Certificate of Appropriateness Case Report

Filing Date: January 4, 2017
Case No.: **2016-007850COA**
Project Address: **88 Broadway Street/ 735 Davis Street**
Landmark District: Northeast Waterfront Landmark District
Zoning: C-2 (Community Business) Zoning District
65-X Height and Bulk District
Waterfront Special Use District No. 3
Block/Lot: 0140 / 007, 008
Applicant: Marie Debor, BRIDGE Housing
600 California Street, Suite 900
San Francisco, CA 94108
mdebor@bridgehousing.com
Staff Contact Marcelle Boudreaux - (415) 575-9140
marcelle.boudreaux@sfgov.org
Reviewed By Tim Frye – (415) 575-6822
tim.frye@sfgov.org

88 BROADWAY FAMILY + 735 DAVIS SENIOR AFFORDABLE HOUSING

CERTIFICATE OF APPROPRIATENESS - REVISION 2

A3.4 LMSA 88 BROADWAY/+735 DAVIS

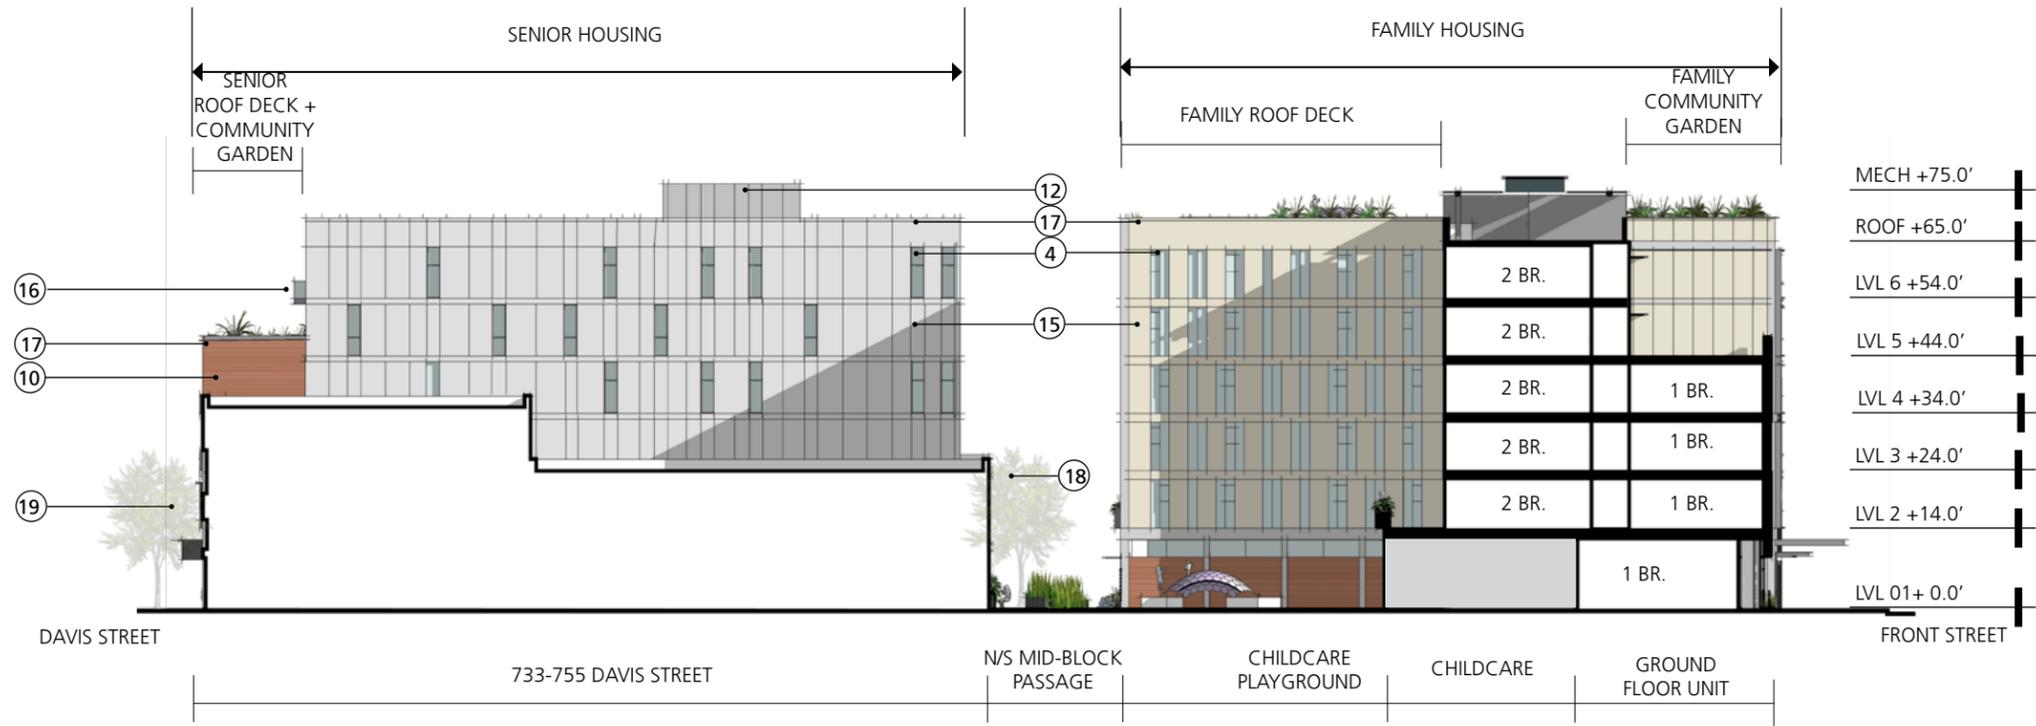
- a. Like the modified fenestration pattern in recommendation 2, the projecting elements have been stacked in the corners of the frame and infill elements with a double-height stacked bay located between the corners. See A3.4 and A3.5.

- a. At the corner of Broadway and Front Street, the 6th floor has been set back 26' on Front Street and 5' on Broadway, effectively eliminating the appearance of a notch at that corner.
- b. The brick elements at Front Street which were originally 4 and 5 stories are now both 5 stories.
- c. A glazed element has been added between the brick and frame and infill buildings on front street to provide a separation between two elements of different material at the same height. See A3.4 and A3.5.
